Re: American Reprographics Company, L.L.C. (f/k/a City Blue Print)
ACEH LOP RO#151
1700 Jefferson Street Oakland, CA 94612

Memorandum

Subject: Response to Memorandum of Comments (Terraphase, July 11, 2017) Regarding the “Addendum to Conceptual Site Model and Work Plan (ERS, January 2013), Additional Investigation Work Plan for 581 18th Street, Oakland, California, 1700 Jefferson Street, Oakland, California” (AWR, July 7, 2017)

Alternative Sampling Locations
 07/17/2017
 581 18th St, Oakland, CA

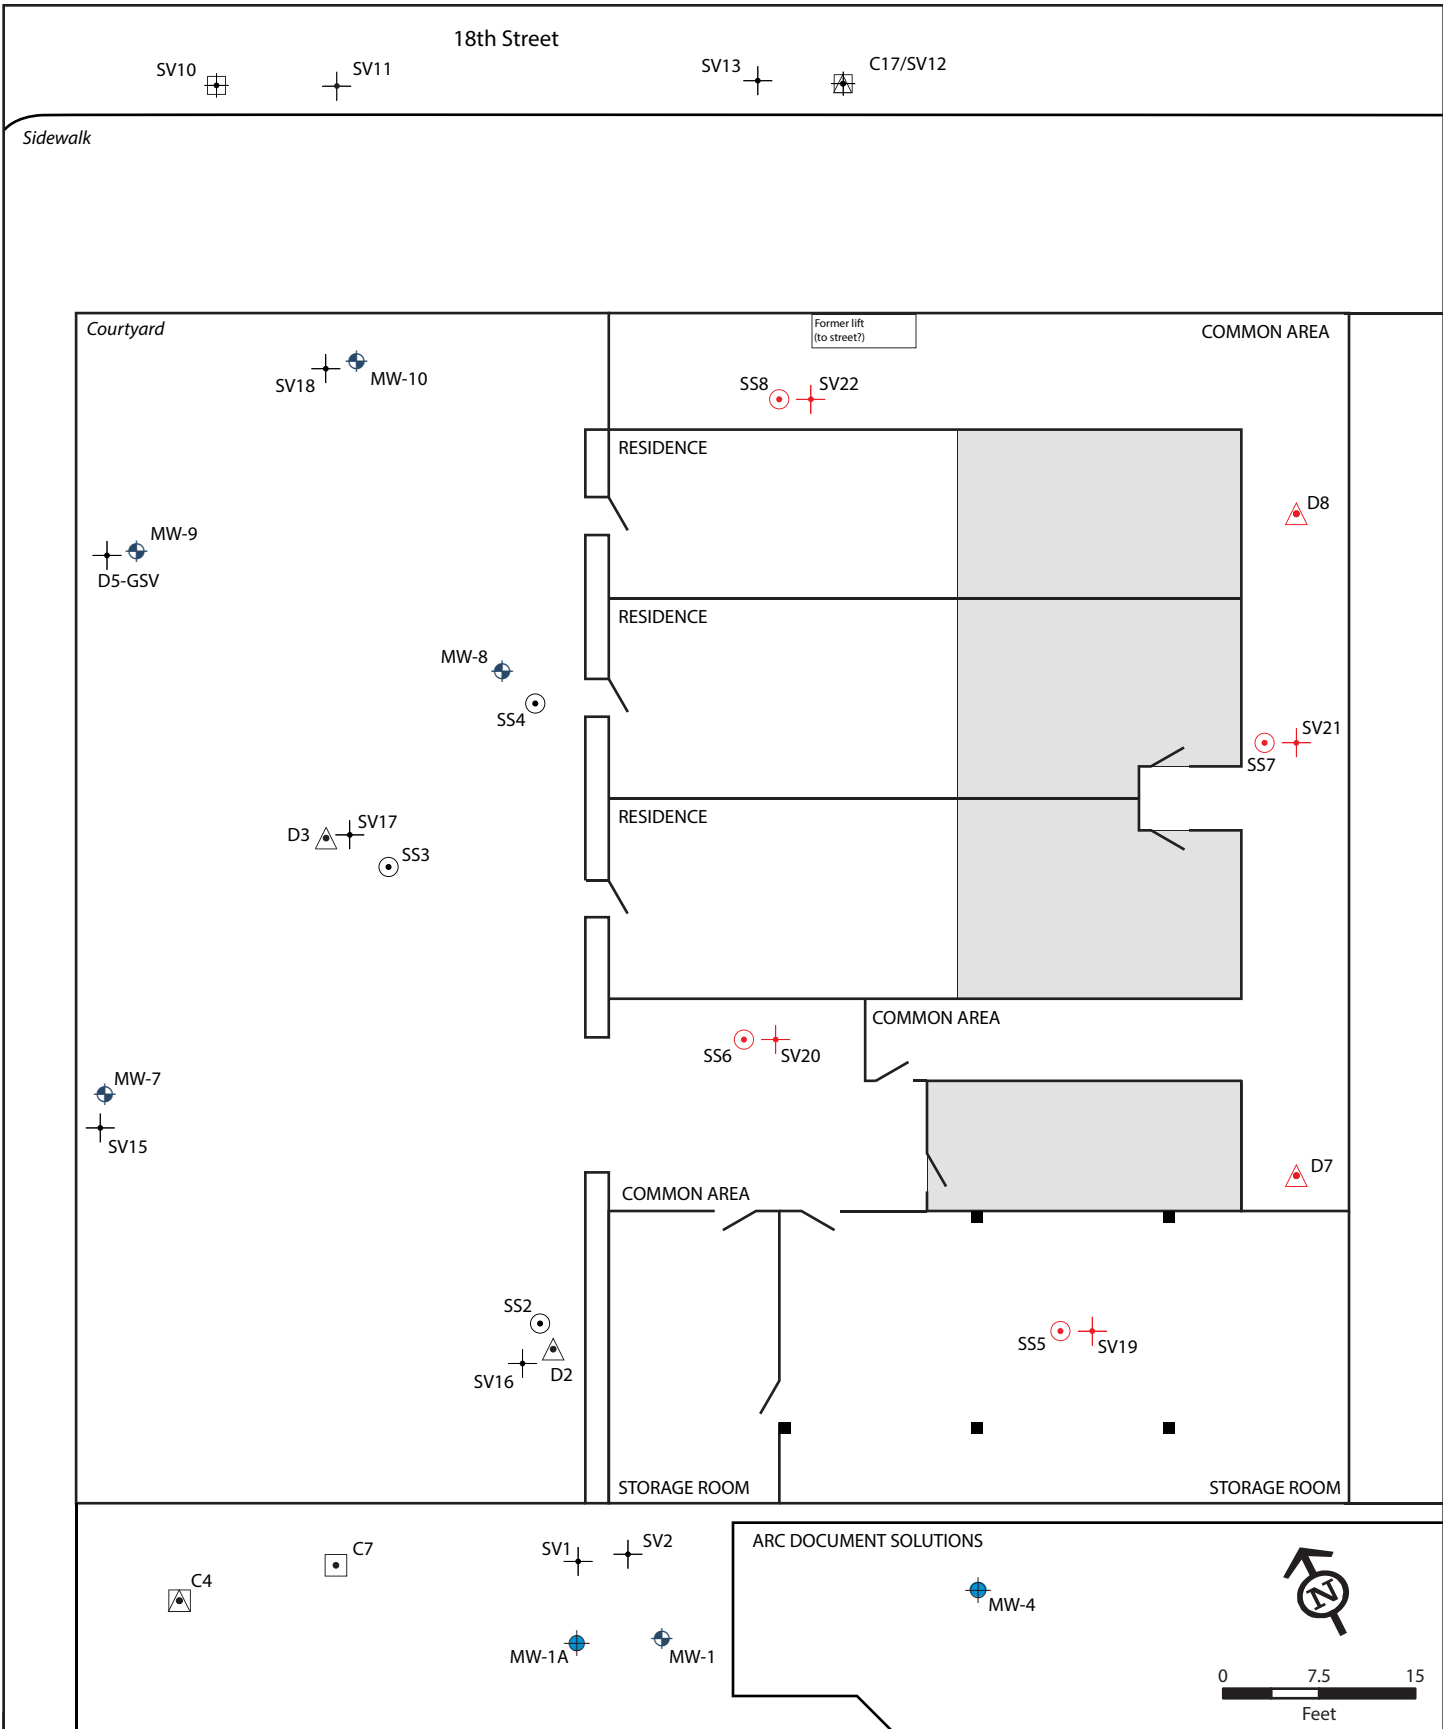
We maintain that when assessing potential risk to indoor air within a residential unit, the optimal location of the sub-slab vapor sample is from within the residential unit, as shown in the Work Plan. AWR's position was explained to Terraphase and Mr. Lo during the building inspection. However, per the Terraphase comments, and as directed by Mr. Lo, AWR will collect sub-slab vapor samples outside the residential units, absent a contrary directive from ACDEH. If warranted by results from the sub-slab vapor samples, we recommend that samples of indoor air be collected from within the residential unit.

The attached figure depicts the alternative sub-slab sampling locations that were agreed to by Terraphase and Mr. Lo during the inspection. We request the ACDEH to decide where the sub-slab vapor samples are required to be collected: either from within the residential unit as proposed in the Work Plan, or at the alternate location proposed by Terraphase and Mr. Lo, as shown on the attached figure.

The attached figure depicts the locations from where soil vapor samples are proposed to be collected. Although different from the locations described in the Work Plan, due to the floorplan revealed during the site inspection, AWR considers these alternative locations for the deeper soil vapor samples will be equally representative.

- 1) The Work Plan proposes soil vapor wells within the building as well as alternate locations in the courtyard should the primary locations be inaccessible. Existing soil vapor well SV4 is proposed to be sampled as an alternative if the SV21 location is inaccessible. SV4 is not shown on the figure or demonstrated to be existing in previously collected data. SS4 is shown on the figure in the courtyard adjacent to the residences and in

recent data however, a sub-slab vapor well should not be used as an alternative to a deeper soil vapor well.

SV4 was misstated in the Work Plan and SS4 would not be used as an alternative. Our response to ACDEH's Conditional Work Plan Approval includes a figure showing revised proposed sampling locations, and the figure attached to this Memorandum depicts alternative sub-slab and soil vapor sampling locations.
